CALIFORNIA REGIONAL WATER QUALITY CONTROL BOARD
SAN FRANCISCO BAY REGION

ORDER NO. 93-056

AMENDING ORDER NO. 90-134 WHICH AMENDED ORDER NO. 89-167, SITE CLEANUP REQUIREMENTS FOR:

APPLIED MATERIALS, INC.
3050 BOWERS AVENUE BUILDING 1 FACILITY
SANTA CLARA, SANTA CLARA COUNTY

Figure 1 Total VOC Concentrations Greater Than 1ppm in the A/A2-Zone Confining Layer at Applied Materials Building 1 Equipment Pad

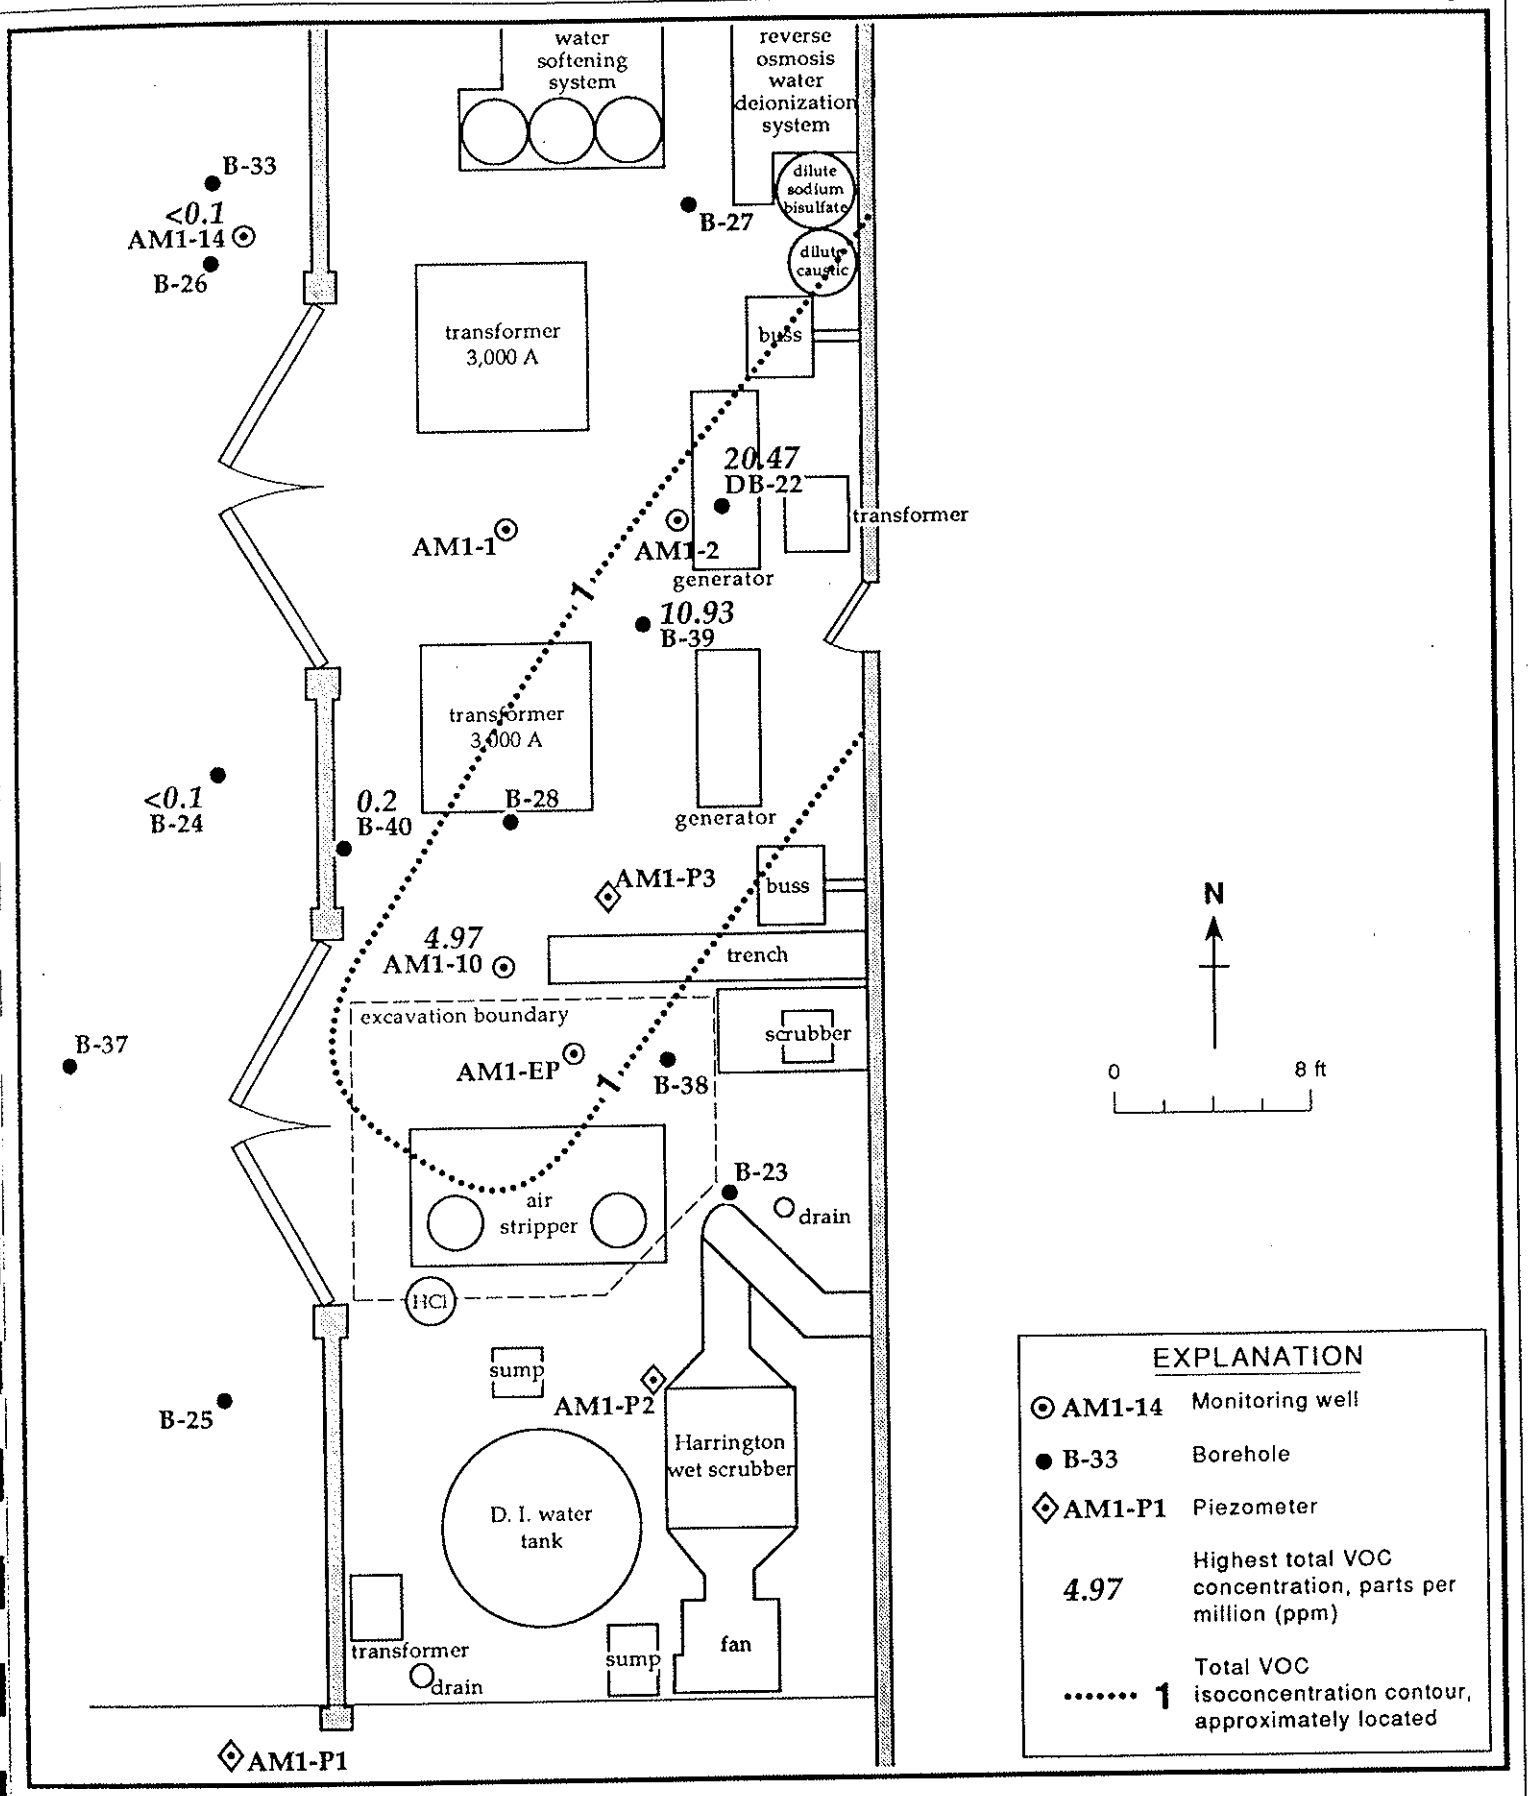
4. The analyses of groundwater samples have verified an interval of volatile organic compound (VOC) pollution in groundwater below the A-aquifer sand near the source area. The VOCs were first detected in 1990. Historically the maximum reported concentrations in well AM1-10 (Figure 1) were 60 parts per million (ppm) 1,1,1-TCA on September 11, 1990, 4.8 ppm 1,1-DCA on January 3, 1991, and 2.7 ppm 1,1-DCE on September 11, 1990. This deeper interval is not controlled by groundwater extraction wells AM1-1 and AM1-5E.

The new extraction well AM1-10 is extracting less than 1 gpm polluted groundwater from this deeper interval, which has been named the A2 zone by the Discharger. In April 1993 the concentrations in groundwater from well AM1-10 were: 7.5 ppm 1,1,1-TCA, 1.0 ppm 1,1-DCA, and 0.27 ppm 1,1-DCE.
